SERVICE BULLETIN

No.**292 72 2073**

ARRIEL 2 C - C-PM - C1

Subject: Module M01 (accessory gearbox). Front support, welding of the rear flange is moved forward.**Application of modification TU 73.**

ANNEXE 1 / APPENDIX 1

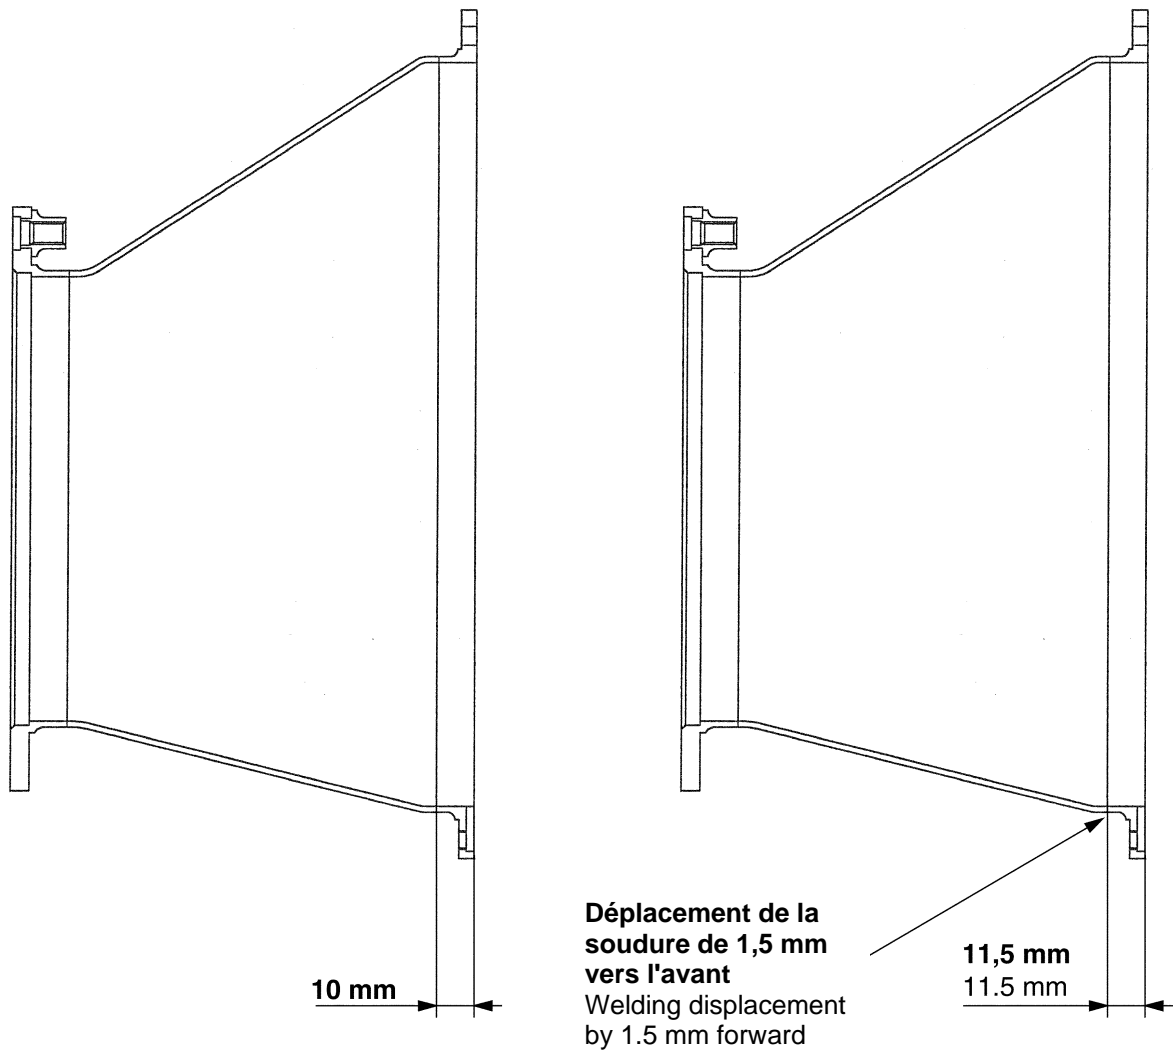
Welding of the rear flange is moved forward to prevent a small radius from being created as this would constitute a potential crack initiation point.

Support avant AVANT TU 73
 PRE TU 73 front support

Support avant APRES TU 73
 POST TU 73 front support
